SERVICE DIRECTIVE BULLETIN NO. T-043

DATE: January 9, 2013

1. SUBJECT: Trim Relay Replacement

2. MODEL: TH-28, 480, 480B

Figure 1: Trim Relay (M83536/10-024M Relay Shown)

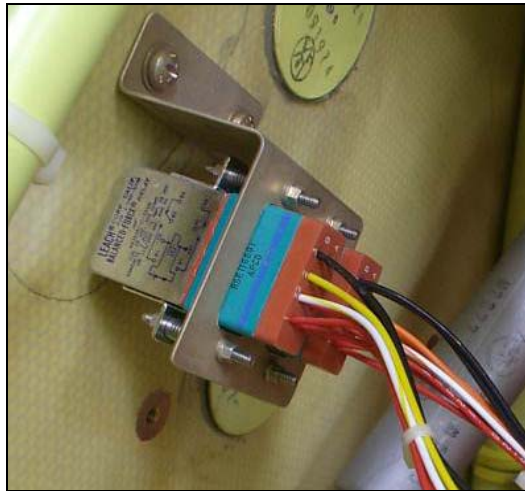
DRI and Leach manufactured relays are installed in aircraft equipped with M83536/10-024M trim relays (Figure 1).

This SDB requires a one-time inspection of the trim system for DRI relays and if necessary, replacement of the DRI relays with Leach manufactured relays.

Within the next 25 hours, inspect the trim system for trim relays manufactured by DRI. If the trim relays are manufactured by DRI, replace with Leach manufactured relays.

Figure 2. Trim Relays (DRI relay shown on left; Leach relay shown on right)

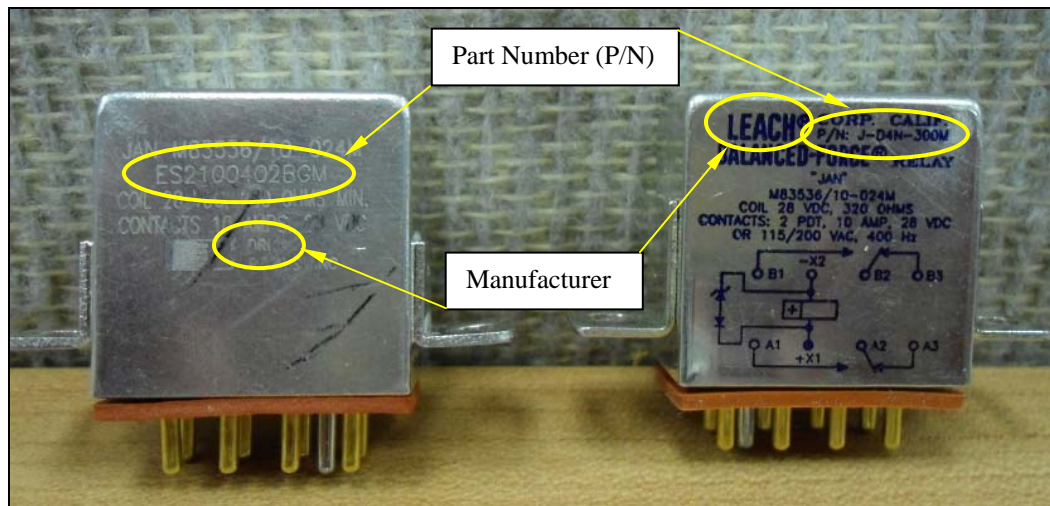
- A. Locate the trim relay assemblies via the left and right side engine access panels.
- B. Inspect the trim relays (4 total) for the manufacturer information printed on the unit (Figure 2).
 1. If the trim relay is P/N ES2100402BGM, replace the relay with P/N J-D4N-300M.
 2. If the trim relay is P/N J-D4N-300M, no replacement is necessary.

- A. Remove the trim relay bracket.
- B. Remove the relay post nuts.
- C. Pull the relay from the socket.
- D. Install the replacement relay.
- E. Reinstall the nuts.
- F. Reinstall the bracket.
